Service Notification

Subject: Introduction of New Waterproof Probe SP-726222 to replace SP-TDR-OP2HSB1 and SP-TDR-OP2HSB2

Products Affected: D920-P Serial No D920P0100000-xx onwards
FD1-P Serial No FD1X0100000-02 onwards
D920-LV All units

Spare Parts

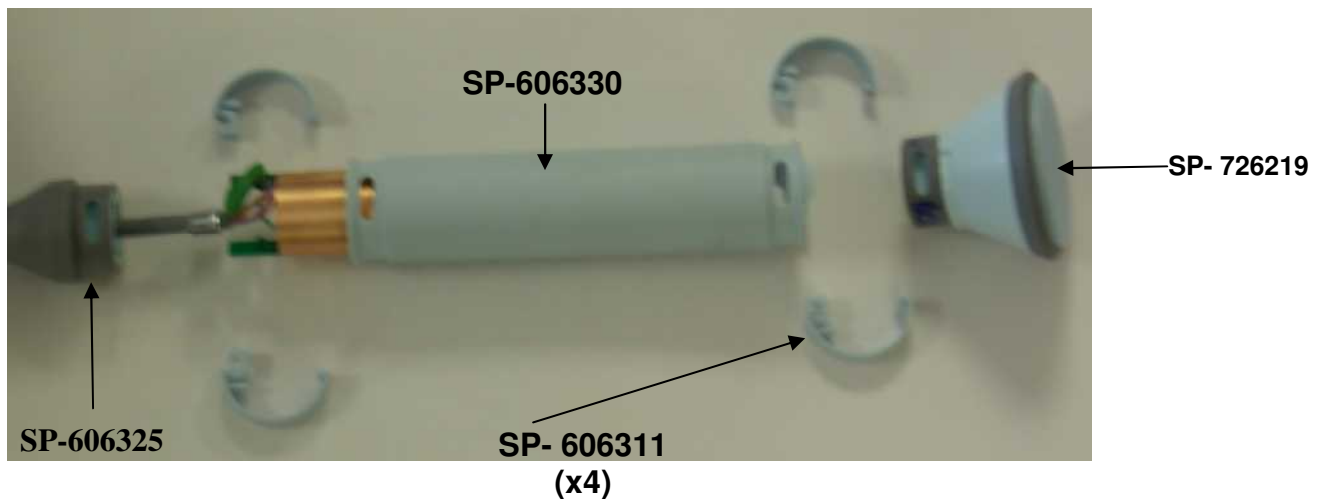
The Photograph below shows the parts which have changed, with the new part numbers. Parts with no numbers attached are the same as the previous aqua probe.

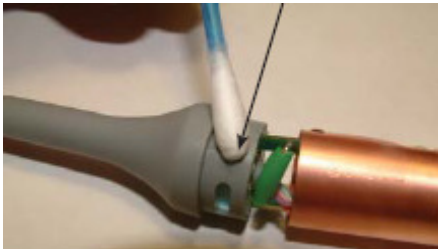
Slide Copper Screen over probe and position so that the internal fold is located against the edge of the PCB. Re-Solder in place using Tinned Copper Wires.
